SEWAGE DISPOSAL SYSTEM

HOWARD COUNTY HEALTH DEPARTMENT

SUBDIVISION The Warfields LOT 29 ROAD 14811 Chestnut Court

SITE PLAN 1"=30'-0"
"THE WARFIELDS"
LOT 29 — 3.00 ACRES ±
ZONING — R
TAX MAP 27
5th ELECTION DISTRICT
HOWARD COUNTY, MARYLAND

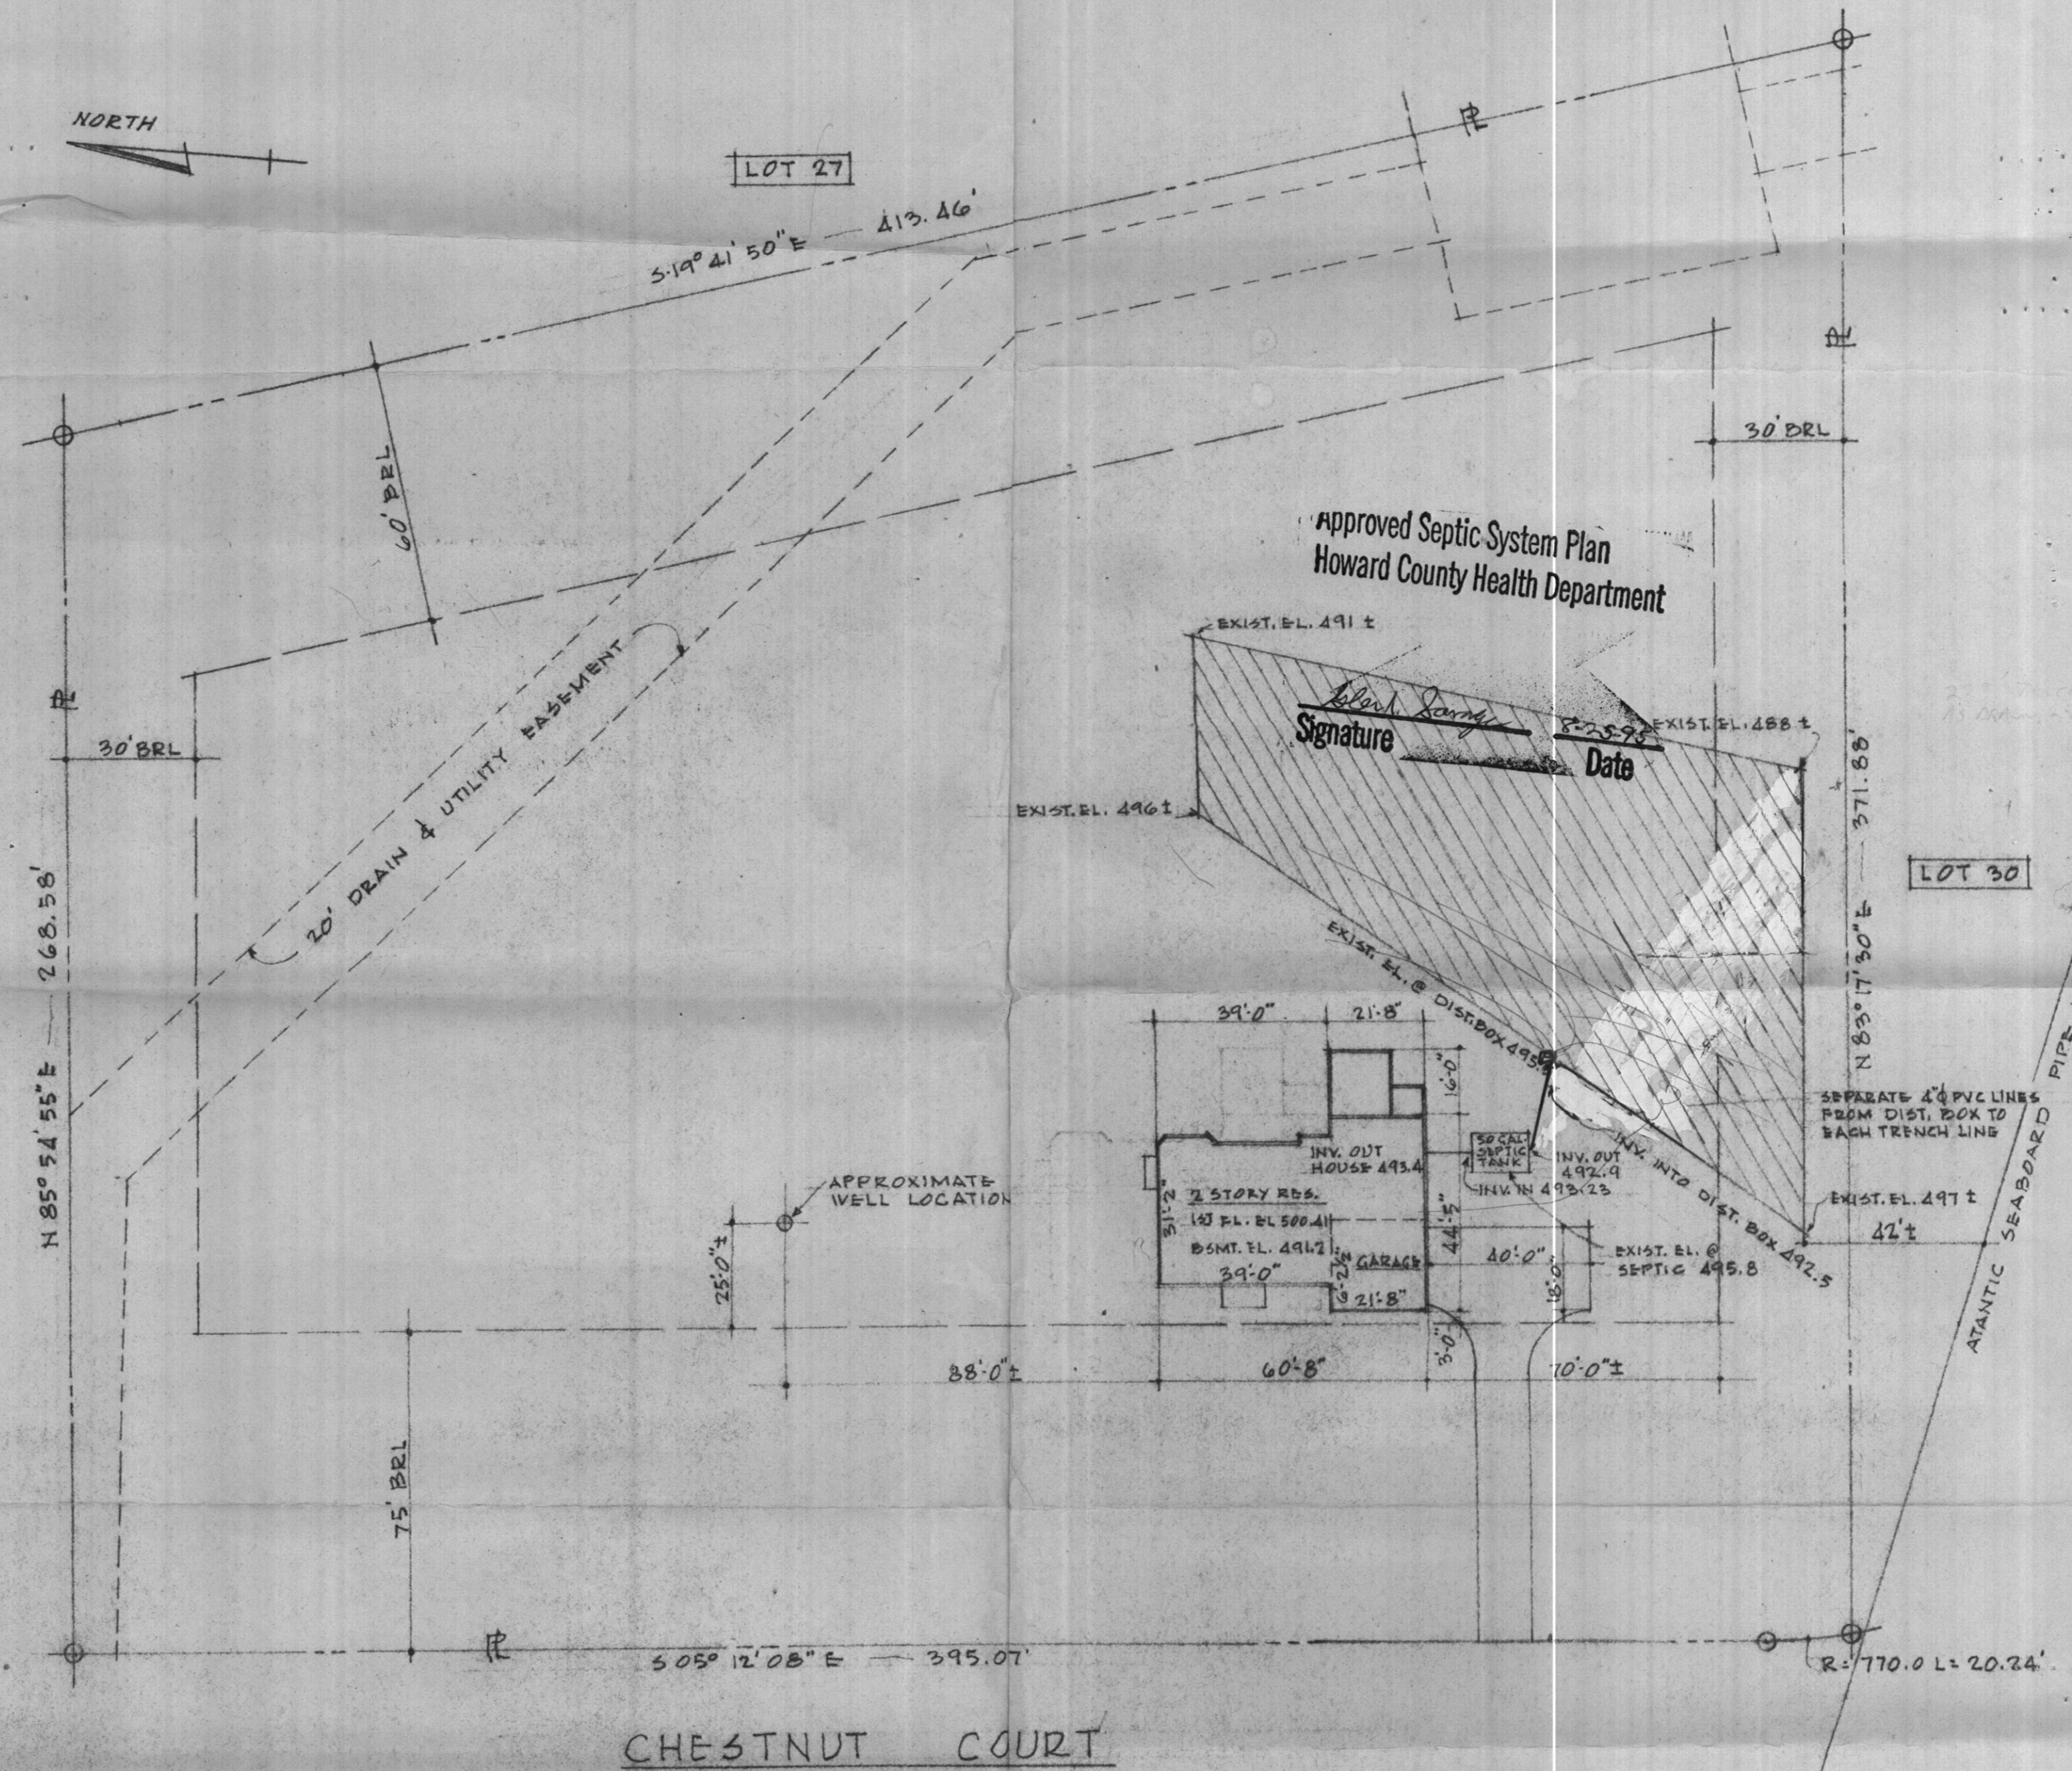
REMARKS: 11/28/95 Septic system installed per permit. Septic contractor provided info attesting to this. No inspections made due to 4 day weekend and impending rain Aug 2-14-96 WELL LINE COVERED, UNABLE TO APPROVE W.P.T. *lf*

LOT 29 WARRIFIELDS
 TENT. OK TO MODIFIED
 SEWAGE DISPOSAL
 EASEMENT
 (MATCHES CONTOUR BETTER)
 7/17/95 *ewald*
